**PLANNED UNIT DEVELOPMENT,  
SUBDIVISION and  
REZONING STAFF REPORT**

**Date: November 21, 2013**

Longleaf Gates Subdivision, Phase Two

# SITE PLAN

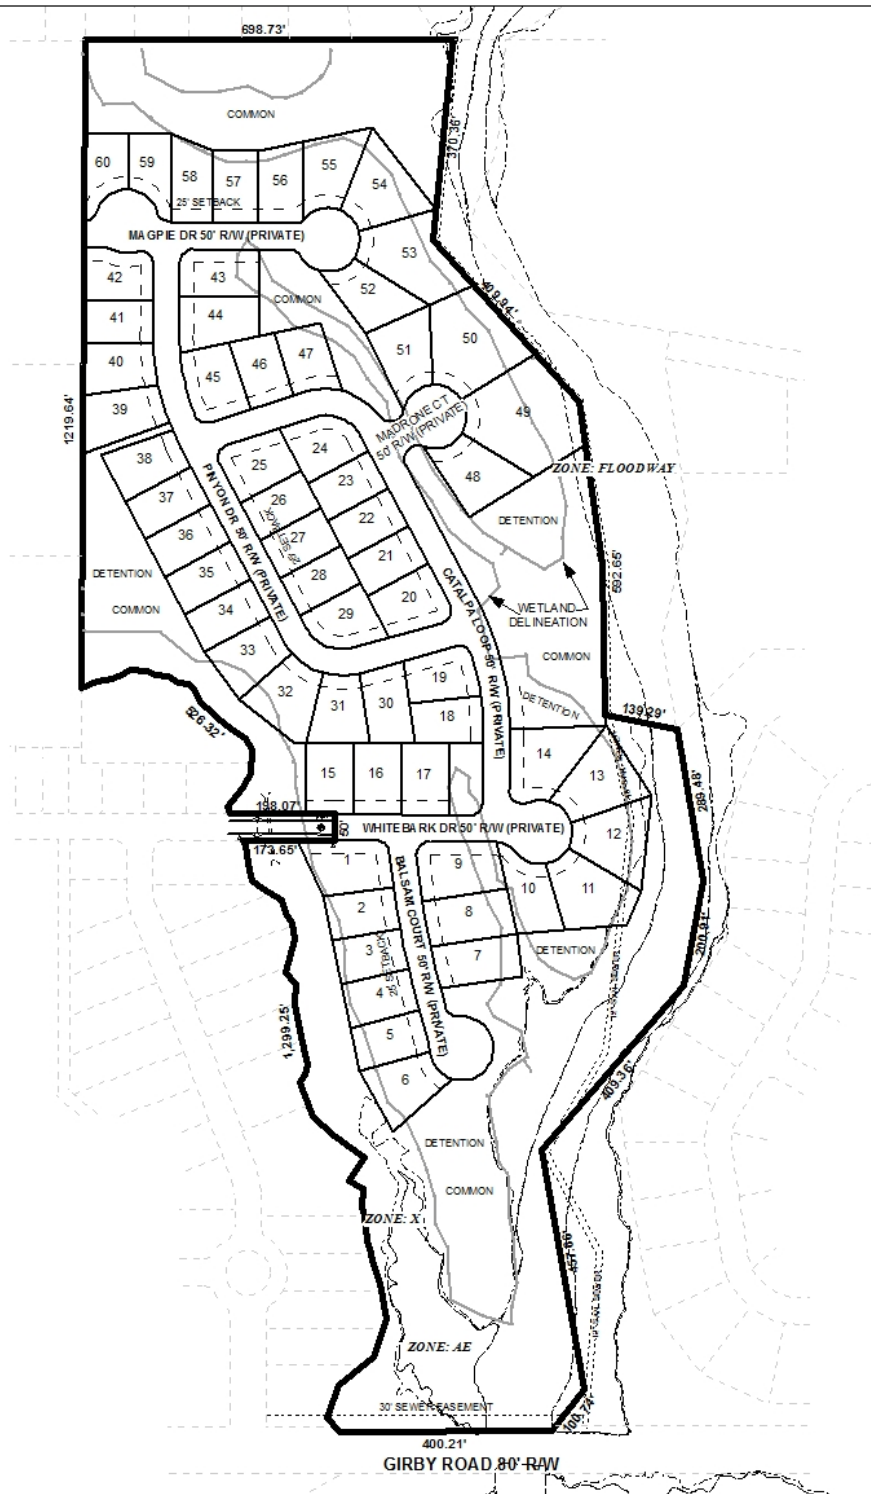
The proposed lots, as depicted, meet the minimum size and frontage requirements as regulated by the Subdivision Regulations. The proposed 25' minimum building setback line is depicted and should also be shown on the Final Plat, if approved. Each lot is labeled with its size in square feet and acres and this, too, should also be shown on the Final Plat, or a table should be furnished on the Final Plat providing the same information, if approved. As the area containing the proposed lots is zoned R-2, a note should be required on the Final Plat stating that each lot is limited to 40% maximum site coverage by all structures.

A note on the plat indicates that a 10' drainage and utility easement is dedicated along the front of all lots and along the side of lot lines abutting a right-of-way. Other lots are indicated to have an easement crossing the lots. Although the 25' minimum building setback line would negate the construction of any structure within the dedicated 10' easement within the setback, a note should be required on the Final Plat stating that no structure may be constructed within any easements.

The site has frontage on Girby Road, a component of the Major Street Plan with a planned 100' right-of-way. As the plat indicates a current right-of-way width varying from 80' to 90' along the Girby Road frontage, dedication would be required to provide 50' from the centerline of Girby Road. Revision of the labeled size of the Southern common area may be necessary due to the dedication. Proposed streets within the subdivision are indicated to have a compliant 50'

A large portion of the site is indicated to be common areas. The area adjacent to the East side of Lot 18 is not identified, but a telephone conversation with the engineer indicates this is to also be a common area; therefore, the plat should be revised to label this area as such with its size in square feet and acreage. A note should be required on the Final Plat stating that the maintenance of the common areas (detention areas) is the responsibility of the property owners.

*The applicant submitted the Rezoning application and addressed most of the items listed. The revision of the labeled size of the Southern common area following the required dedication along Girby Road was not made, and the shortened street-stub off the West terminus of Magpie Drive leading to the vacant land locked property to the West was not labeled "emergency access only". With minor revisions, the Subdivision and PUD could be considered for approval, subject to the Rezoning being approved. It should be noted that, since the Rezoning would change the over-all zoning on the site to R-1, the Subdivision should be limited to 35% maximum site coverage by all structures on any lot.*

- 1) completion of the Rezoning process prior to signing the Final Plat;*
- 2) revision of the Current Zoning classification on the plat to R-1;*
- 3) retention of the 25' minimum building setback line on the Final Plat;*
- 4) revision of the plat to show the cul-de-sac at the West terminus of Magpie Drive, in agreement with the PUD and Rezoning site plans;*
- 5) retention of the labeling of the all lots and common areas with their sizes in square feet and acres, revised for any required dedication, or the furnishing of a table on the Final Plat providing the same information;*
- 6) placement of a note on the Final Plat stating that each lot is limited to 35% maximum site coverage by all structures;*

- 1) *completion of the Rezoning process;*
- 2) *revision of the Current Zoning classification on the site plan to R-1;*
- 3) *revision of the site plan to show the cul-de-sac at the West terminus of Magpie Drive;*
- 4) *retention of the 25' minimum building setback line on the site plan;*
